### SIB 35 01 23

### CREAKING NOISE FROM THE BRAKE PEDAL AREA

This Service Information Bulletin (Revision 1) replaces SI B35 01 23 dated April 2023.

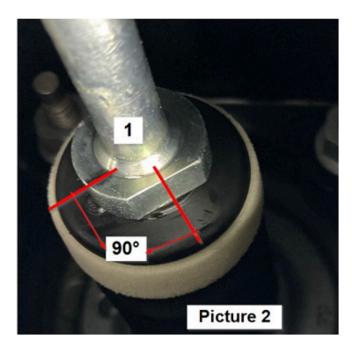
When the brake pedal is pressed/ released, a creaking noise may be heard from the pedal area for the Integrated Brake System (IB).

Unfavorable tolerance in the connection between the pedal mechanism and the IB.

Adjustment of the IB piston rod in the area indicated by the red arrow

2. Mark the piston rod (1) to set the starting point for a 90° clockwise rotation

- 3. Using channel lock pliers with **protected jaws**, turn the piston rod clockwise by 90° **NOTE:** It is important not to damage the piston rod
- 4. Does the noise still occur after the piston rod adjustment of 90° (vehicle stationary, engine running: no road test needed)?
